Report of the Chief Planning Officer

PLANS PANEL EAST

Date: 7th June 2012

Subject: 12/00547/FU – Part two storey, part single storey side and rear extension;

Nunroyd Road Ground floor - Proposed 1:100 @ A4| 09-11-13 | 09125/03 Rev G

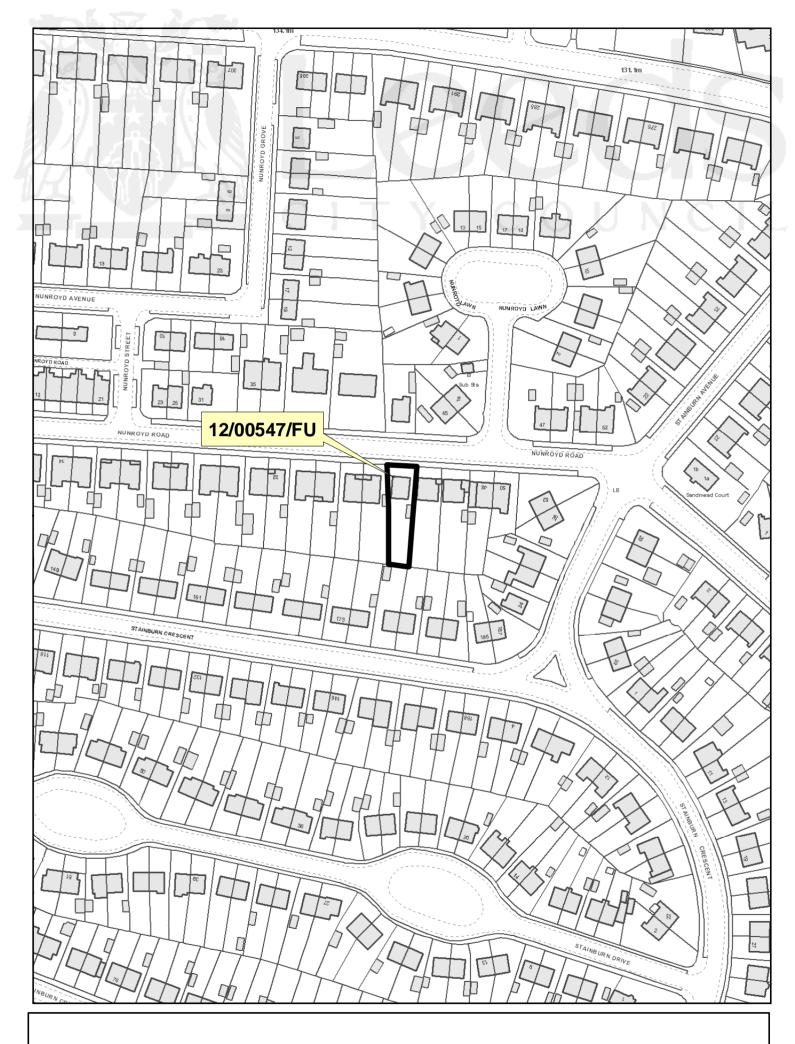
- 10.2 The proposal is not considered to achieve this aim. The changes which have been made to the design are as follows:
 - the roof of the extension has been raised so that it now sits above the house eaves line:
 - the external finish is now a mix of brick and render rather than wholly render;
 - an element to the east side has been reduced from two to single storey.

- 10.3 The increased height of the extension roof is considered to be a backward step in making the extension have a greater measure of design consistency. It is usually expected that extensions will respect the scale of existing dwelling and that the various elements of an extension will not overdominate or overwhelm the house. To have changed the extension from one in which the height overall height did give a degree of subordination, to one in which the extension sits above the eaves line of the house is not considered to be a positive change. The degree of discord between the existing house and the extension is increased, rather than decreased by this change. As such this does not address the comments of the Inspector nor the concerns of officers.

- 10.4 The reduction of the amount of render is some benefit as the introduction of bricked elements does mean that some of the materials of the extension match those of the house. However, that said, the extension does still include large areas of render and this means that is not consistent with the character of the existing property. In his decision the Inspector noted that the extension would be visible from the streetscene and also raised concerns regarding the impact of the extension upon the character of the wider area. The use of visible areas of render to the front and side of the property is therefore not considered to be acceptable.

- 10.5 The removal of a small area of first floor massing is also not considered to result in a greater measure of design consistency. The extension still has a wrap-around form (a matter the Inspector considered added to the conflicting design) and in fact the removal of this element introduces a further step into the extension and further complicates its shape and design. This means that it fails to reflect the simple, clean lines of the existing property and is therefore considered to be an out of character addition.

10.6 As such the extension is still considered to be a harmful addition. It remains a contrasting, contemporary flat roofed addition, which with its contrasting materials and feature glazing does not adequately reflect the traditional character of the existing house and surrounding properties. It will therefore have an adverse impact upon the character and appearance of both the house and its surroundings. The application has therefore not adequately overcome the previous reasons for refusal and the comments of the Inspector. It fails to comply with policies GP5 and BD6 of the UDP Review (2006) and also with the guidance contained within policy HDG1 of the Householder Design Guide.
